UNITED STATES
DEPARTMENT OF THE INTERIOR
BUREAU OF LAND MANAGEMENTOCD-ARTESIA
NM OIL CONSERVATION
ARTESIA DISTRICTFORM APPROVED
OMB NO. 1004-0137
Expires: January 31, 2018**SUNDRY NOTICES AND REPORTS ON WELLS**
Do not use this form for proposals to drill or to re-enter an abandoned well. Use form 3160-3 (APD) for such proposals.

BOPCO, LP respectfully submits this sundry notice of intent to plug and abandon the referenced well.

Conditions of Approval

Poker Lake - 170, API 3001531744

Poker Lake Unit #170 Current and Proposed WBD's

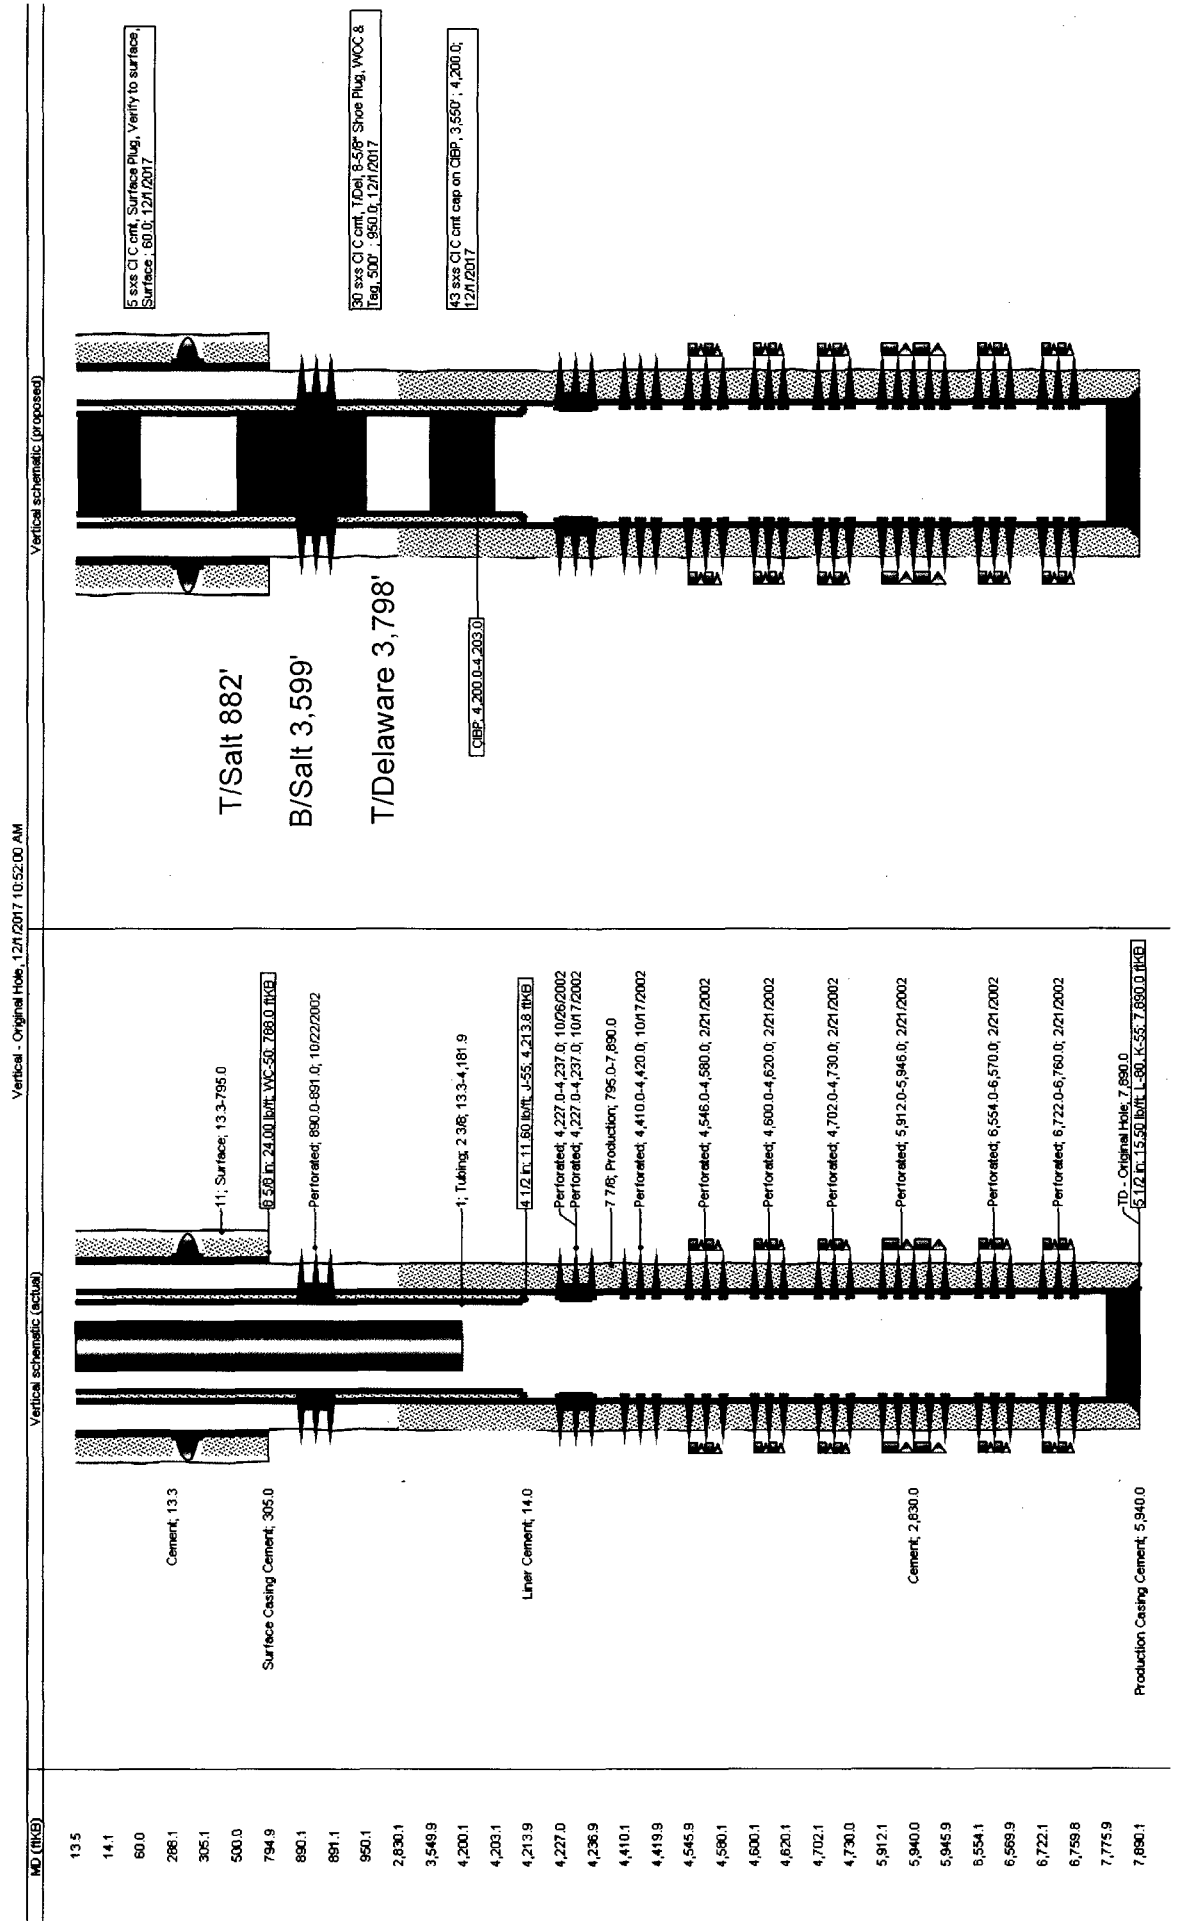
1. MIRU plugging company. ND tree and NU 3K manual BOP. Function test BOP. POOH and lay down IPC tubing and packer.

2. PU 4-1/2' CIBP and RIH to 4,200' and set. Tag CIBP to verify. Pump 43 sxs Class C cmt on top of CIBP. (Perf plug, T/Del, B/Salt)

3. PUH to +/-3,550', spot 9.5# salt gel from +/- 3,550' to surface.

4. PUH to 950', spot 30 sxs CI C cmt from 950' - 500'. WOC & Tag. (T/Salt, 8-5/8" shoe plug)

5. PUH to 60', spot 5 sxs Class C cmt from 60' to surface. Verify to surface (Surface plug).
6. ND BOP and cut off wellhead 5' below surface. RDMO equipment. Set P&A marker.

Well: POKER LAKE-170
 API: 3001531744
 @ Srfce: T23S-R30E,33.2180s1980w
 @ M TD: T23S-R30E,33.2180s1980w
 Estate: F/F/F

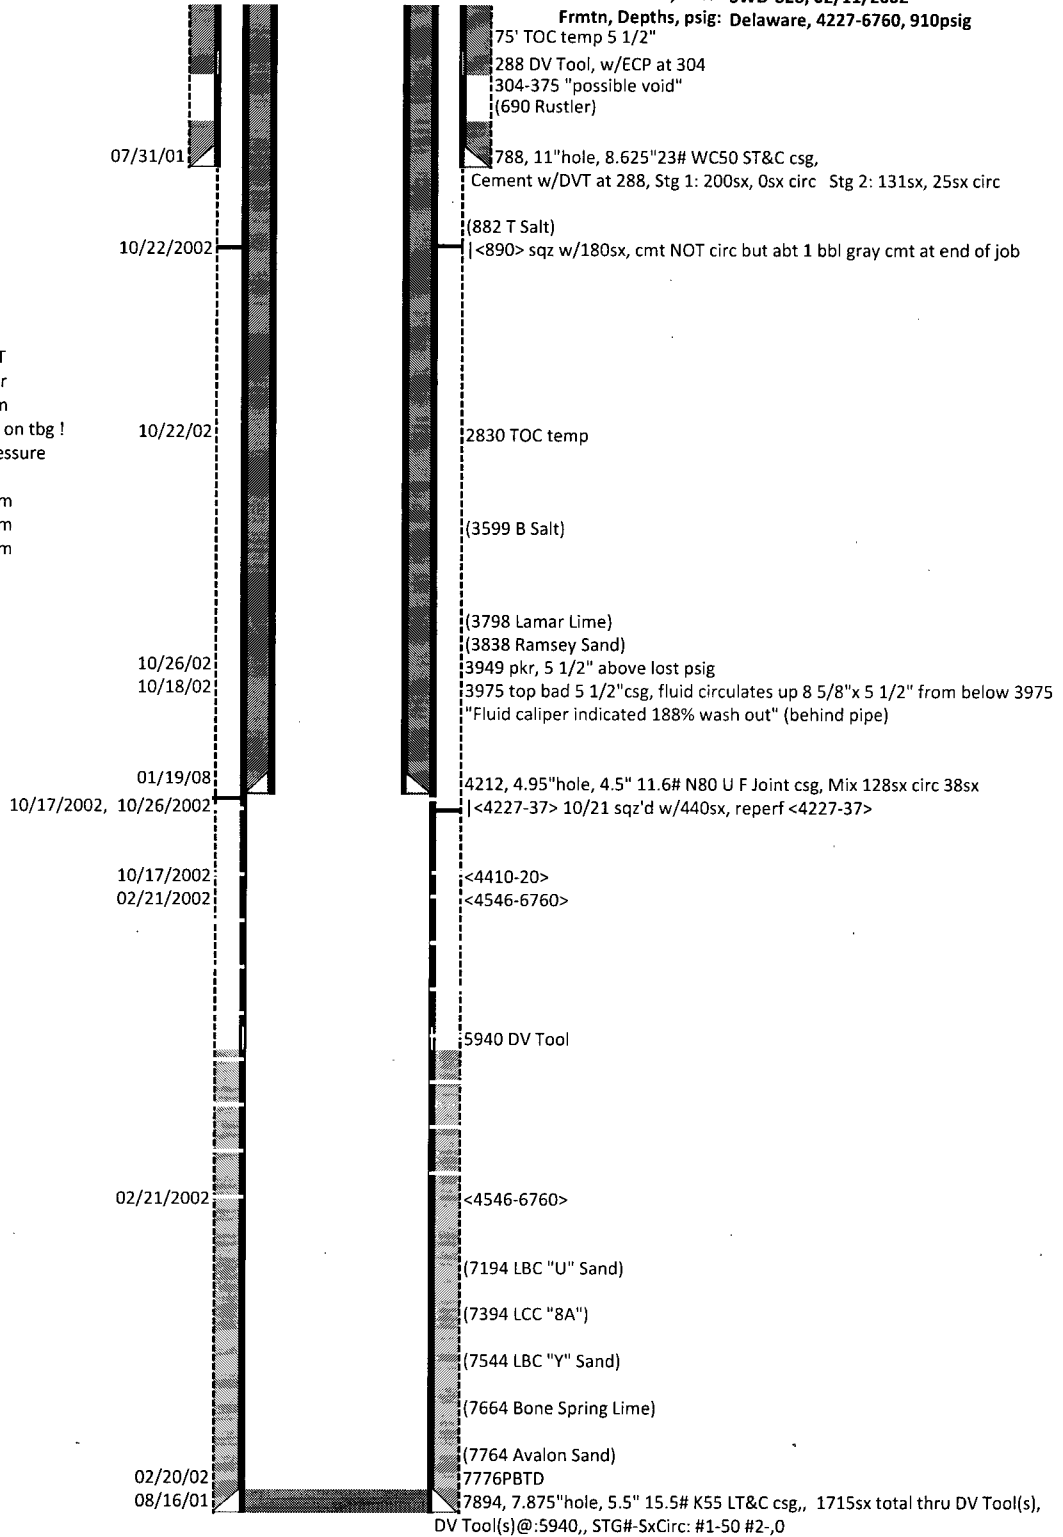
1. Area considerations for this location: A. Secretary Potash R-111-P (3 strings circulated) and B. High Cave Karst (two casing strings, both to circulate cement to surface). Note that the wellbore construction for this well never met those considerations. Reopening the top squeeze perfs <4227-37> were a ploy to facilitate plugging procedures because of the liner depth.

17. **Set the 4 1/2" CIBP at 4200' (within 100' of the top perf of 4227'). Pressure test the casing to 500psig after setting CIBP.**
 18. Secretary Potash R-111-P sections require a solid cement plug across the salt section.

19. **Spot a min of 90sx Class "C" cmt plug on the CIBP.**
 20. **WOC, and tag the plug with tbg at 2894' or above. Top of cmt behind 5 1/2" reported to be 2830 by a temperature survey taken 02/22/2002.**

21. **Open the 5 1/2" x 8 5/8" csg vent and confirm that annulus is isolated to below the 8 5/8" shoe at 788' with a pressure test. With a positive test, proceed. A negative test requires modification of the procedure.**

22. **Perf the through 4 1/2" and 5 1/2" csgs at 2800' and 930'. Set a pkr below 930' and establish circulation between the two sets of perfs.**
 23. **Set up for a suicide sqz. A 275sx Class "C" slurry may be sufficient to cover the salt section behind the 5 1/2" csg from 2800' to 930'.**

24. **Use approximately 130sx Class "C" cmt plug to cover the (2800' to 930') salt section inside the 4 1/2".**
 25. **Perf at 60' or below. Establish circulation through the 4 1/2" x 8 5/8" annulus. Fill with (±20sx) balanced "C" cmt plug and verify the 4 1/2" x 5 1/2" x 8 5/8" annulus and 8 5/8" csg from 60' cemented to surface.**
